From: David Hugh-Jones [david@oysters.co.uk]
Sent: 26 October 2009 16:42
To: Sonja Smith
Subject: Submission re WWDL D0056-01 Midleton WWTP (1)
Attachments: 091026 EPA WWDL.doc; Image0001.JPG; Image0002.JPG; Image0003.JPG; Image0004.JPG; Image0005.JPG; Image0006.JPG; Image0007.JPG; Image0008.JPG; Image0009.JPG; Image0010.JPG

Application by Cork County Council for a Waste Water Discharge Licence for Middleton WWTP, Co. Cork : D0056-01.

BALWICK 1 PUMPING CHAMBER SHOWING AT WHAT DEPTH IN THE STORM CELLS EFFLUENT WILL REACH THE INVERT LEVEL OF THE OPES TO RIVER (3.84m DEPTH)

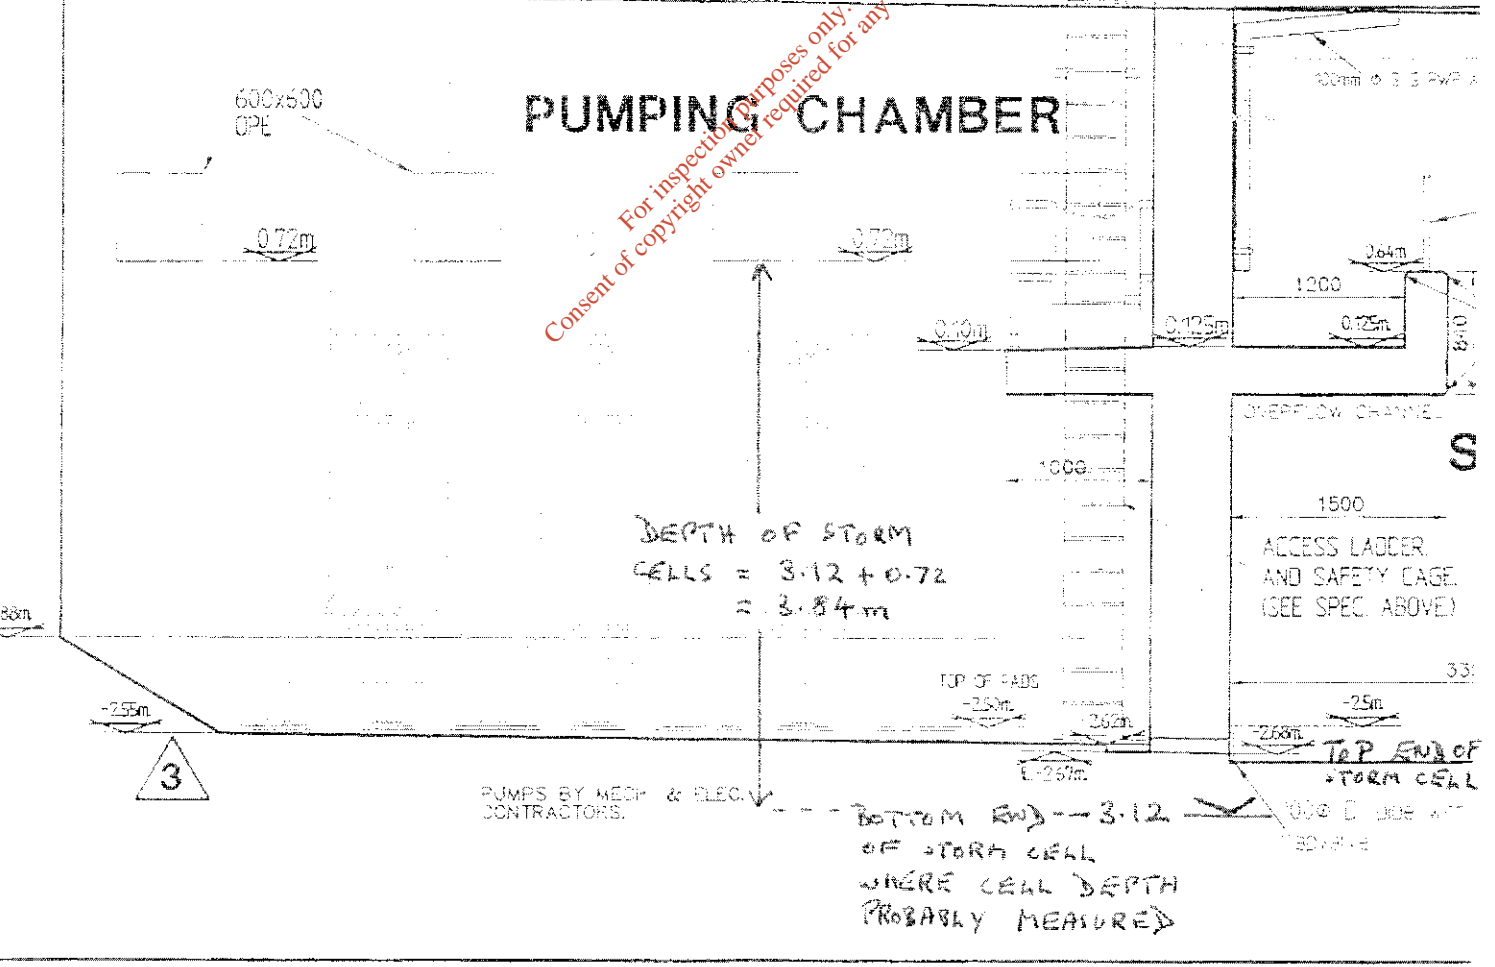
3. Since November 2008, I have asked for the instantaneous Hydroranger record of the storm cell depths in both Bailick 1 and 2 and, at last, I can see for how long the levels in the final cell 3 of Bailick 1 have been higher than the invert of the opes to the river. I enclose part of Drawing 128 Rev. 4 (2) to show that this invert level is set at a depth of the storm cells of 3.84m. If this depth is exceeded, even by a small amount, I am told by the manufacturer that there will be flow by gravity through the Tideflex non-return valves to the river. I have given you the Tideflex flow diagrams previously.

I enclose instantaneous graphs for cell 3 from October 28th to November 25th 2008 (3). You will see that cell 3 was at a level equivalent to about 3.9m depth of effluent. The storm pumps were being used all the time to some extent (400-1,000m³/day see (4)), but the effluent level was maintained at a constant few centimetres above the invert level of the opes. 14mm of rain on November 6th sent the effluent level up to about 4.34m, **which would have had the opes flowing nearly full and this happened several more times. These are records of gravity flows from the Bailick 1 storm tanks to the river.**

Ballick 1 Storm Level 3

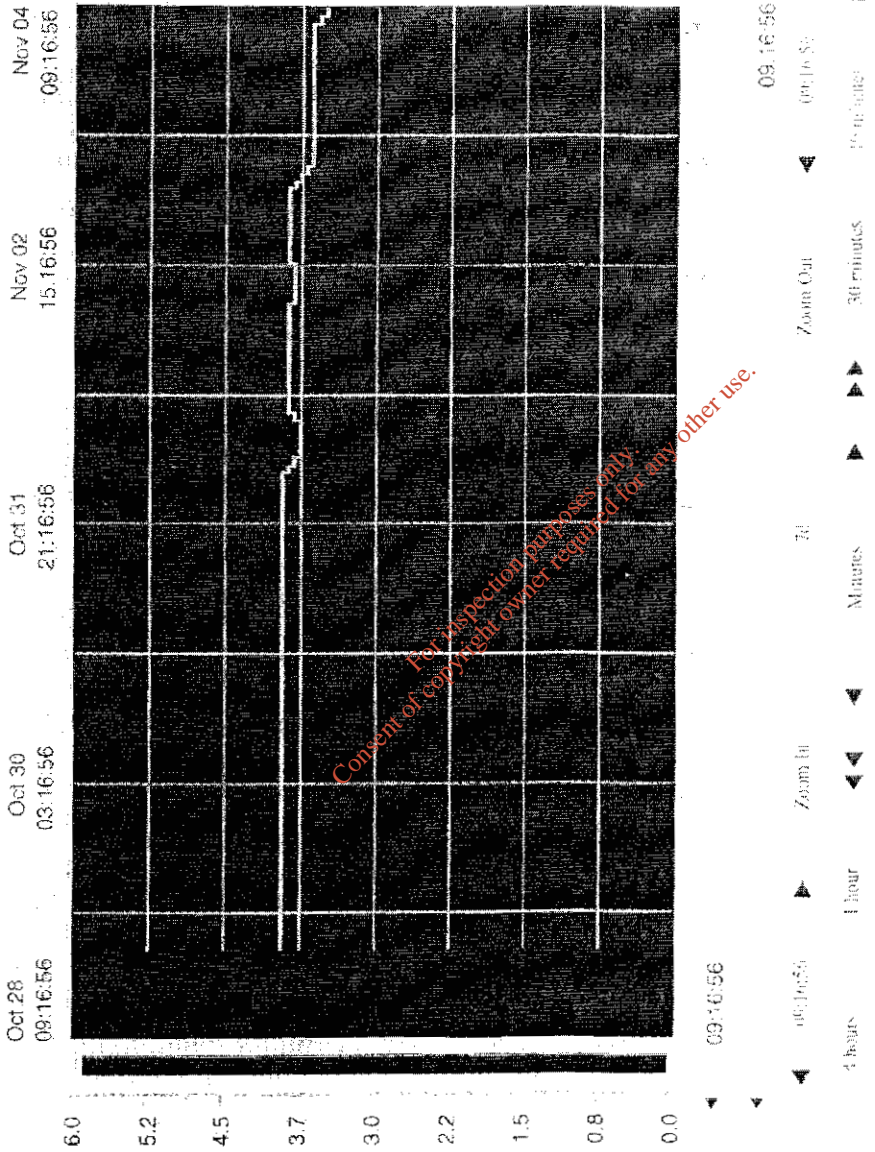
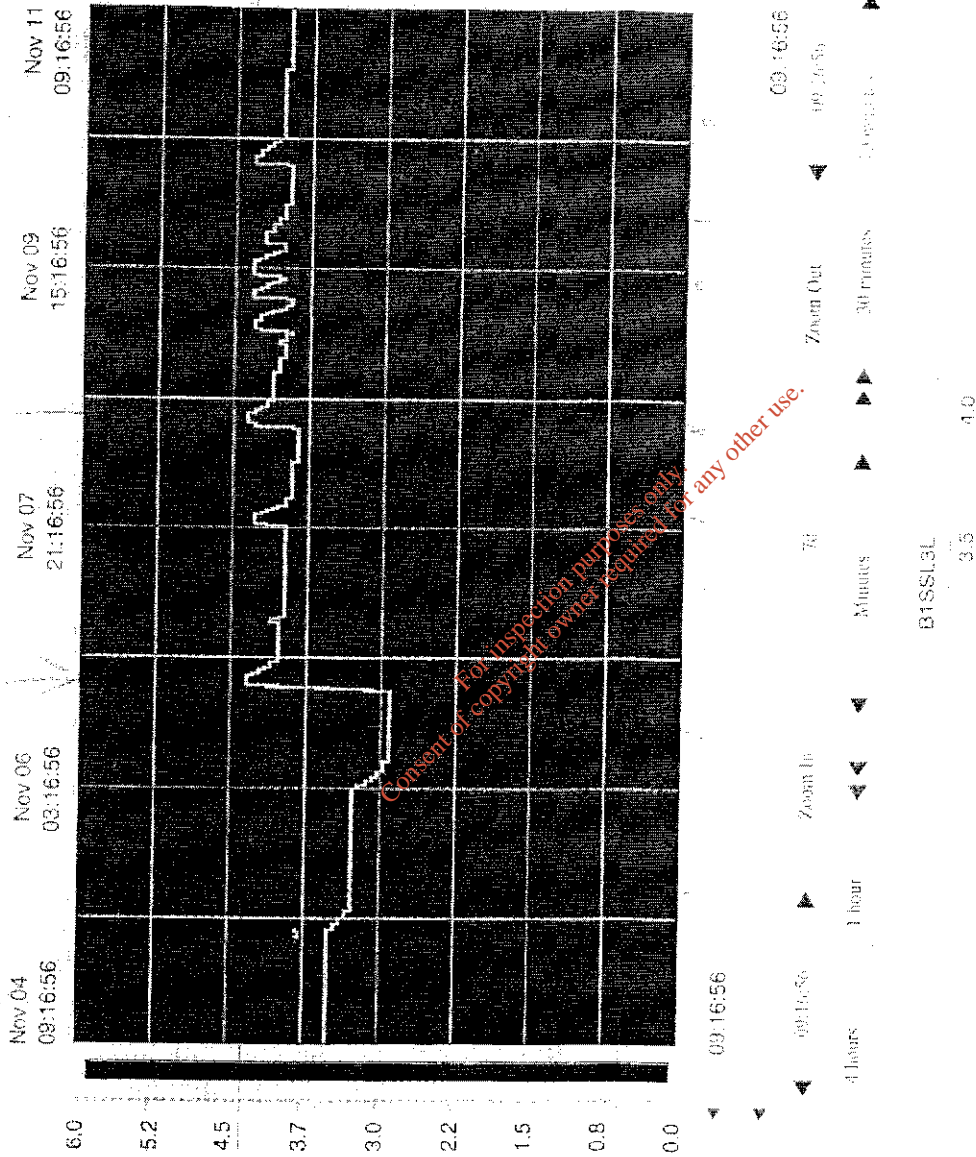
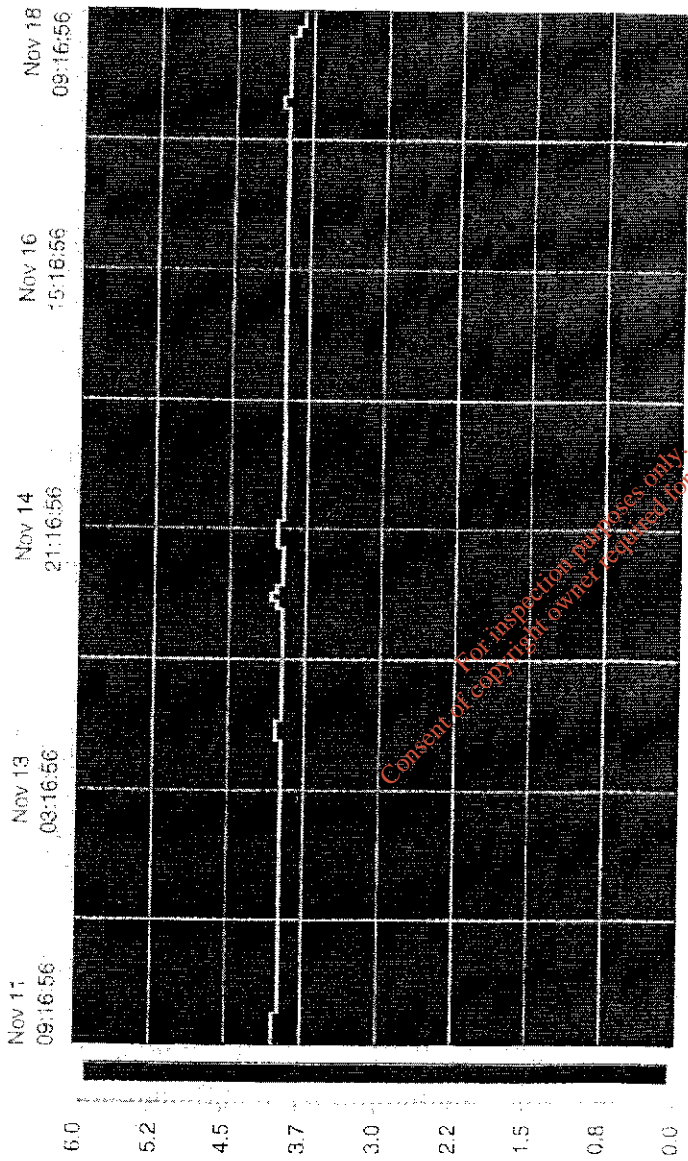
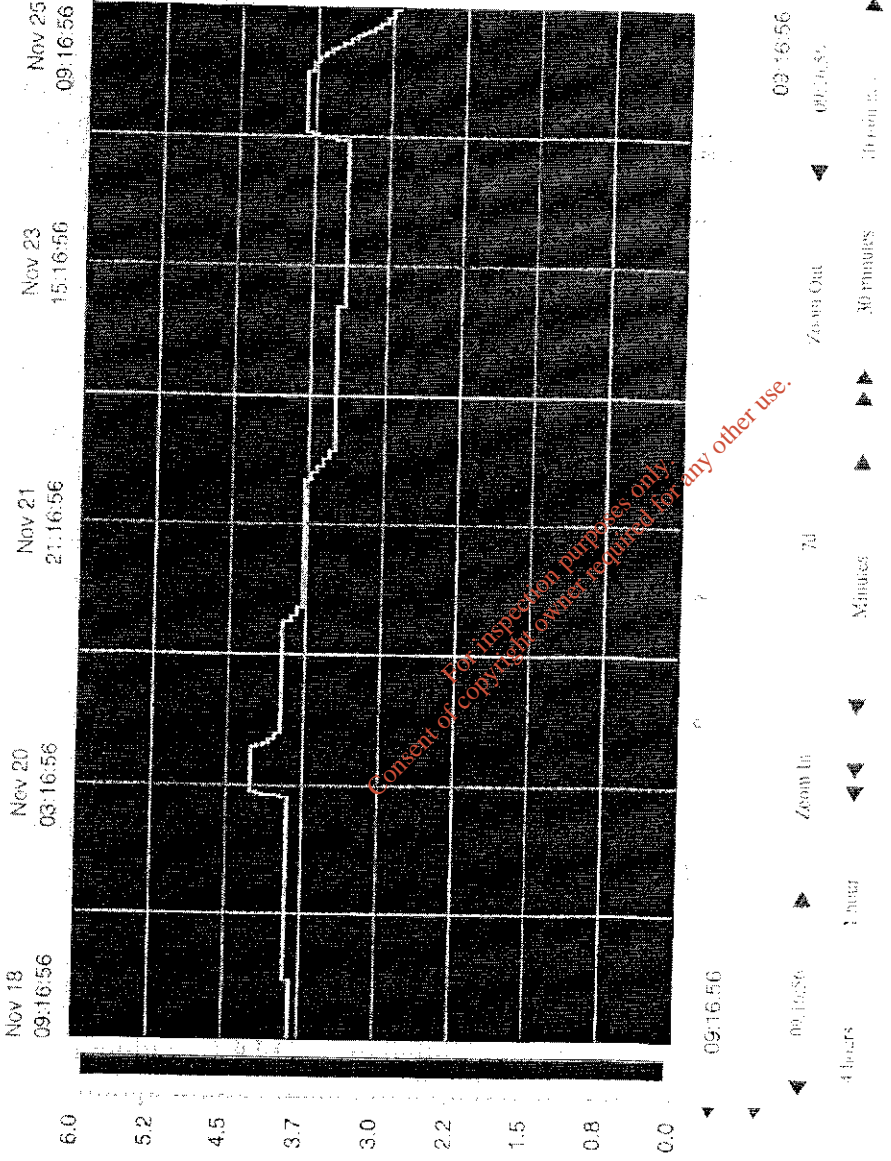
By Nov. 11th the storm pumps were coming on enough to keep the water level just above ope invert level. On Nov. 14th and 15th, 58mm of rain fell and on the 16th 11,999m³ of effluent had to be pumped by the storm pumps to the river. It would seem that they handled this easily enough with their huge capacity (550m³/hr) and the final effluent level hardly altered.

Investigation re March 7th/8th B.1 pump stoppage (S.1)
 2009
 (1/7/09 JH)

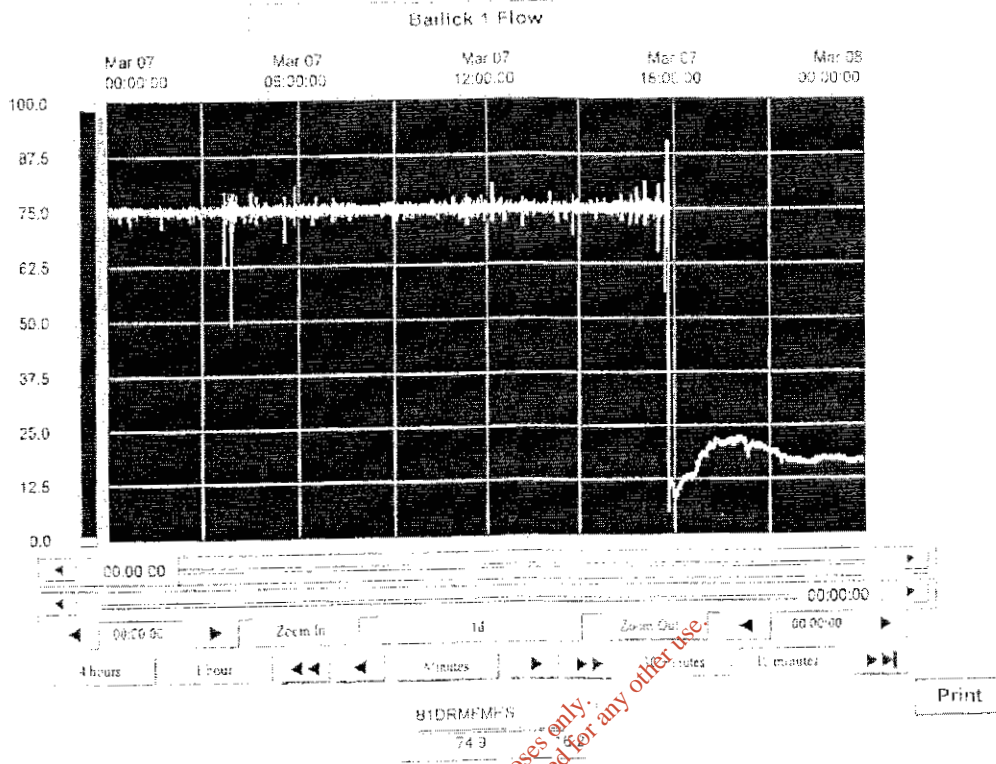
16 hours with very reduced flow
 from 75 l/s to 16 l/s = drop of 59 l/s
 $\frac{59 \times 3600}{1000} \text{ m}^3/\text{hr} = 212 \text{ m}^3/\text{hr}$
 for 16 hours = $16 \times 212 = 3,400 \text{ m}^3$

Storm overflows recorded on 8th/9th were $1,148 + 356 \text{ m}^3$
 = $1,504 \text{ m}^3$

Therefore amount overflowing by gully = $3400 - 1504$
 = 1896 m^3

(This is the third, final, cell) - line

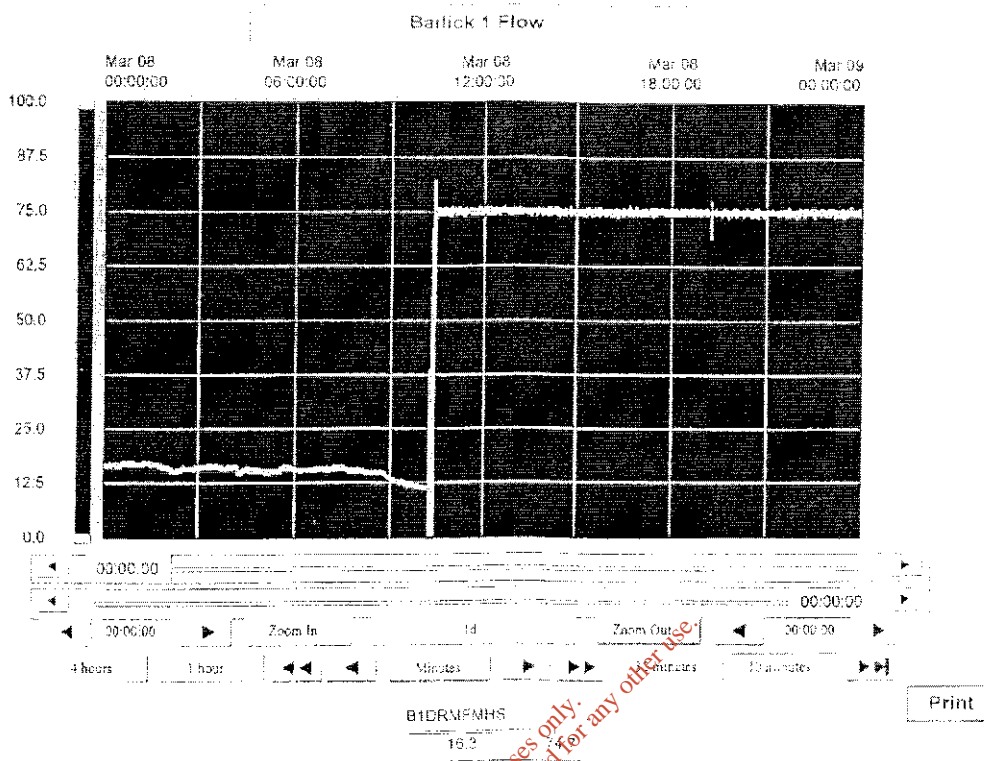
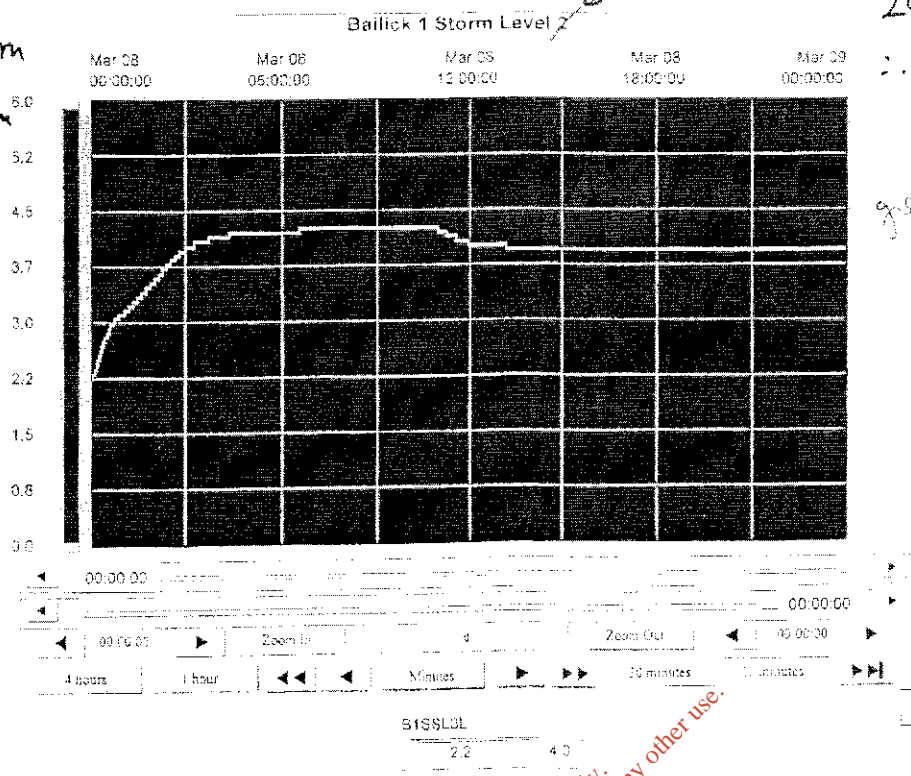
4. We can learn even more than this. Armed with the Tideflex flow diagrams; the duration and heights of effluent above the ope invert; and then one further bit of information provided occasionally from the instantaneous flow from the Bailick 1 foul pumps when they blocked (5.1, 5.2), it actually becomes possible to apportion flow out of the Bailick 1 storm tanks to pumped flow and gravity flow and I attach a worked example. The reduction in flow on March 7th 2009 for 16 hours, due to a pump blockage, meant a drop of 16hrs x 59 l/s (212m³/hr) = 3,400m³. The storm pumps recorded flows of 1,504m³, leaving a further amount that could have been provided by gravity flows of 1,896m³. My calculations, using the Tideflex graphs, estimate that gravity overflows in this period were 1,936m³, which is very close (5.3).

Highest depth $3.7m + (5.5mm \times 0.107) = 4.29m$ for 4.6 hrs

Height above ope invert = $4.29 - 3.84 = 0.45$ (1.4ft)

From Tide flex graphs, flow = 79 m³/hr

Next depth $3.7 + (4.5mm \times 0.107) = 4.18m$ for 2.8 hrs

Height above ope invert = $4.18 - 3.84 = 0.34$ (1ft)

From Tide flex graph, flow = 43 m³/hr.

Gravity overflow

at 4.29m depth	$79m^3 \times 4 \text{ ope} \times 4.6 \text{ hrs} = 1454$
at 4.18 m depth	$43m^3 \times 4 \text{ ope} \times 2.8 \text{ hrs} = 482$
	1936 m

Difference with calculation from storm overflow & drop in flow = $40m^3$, or 20% error
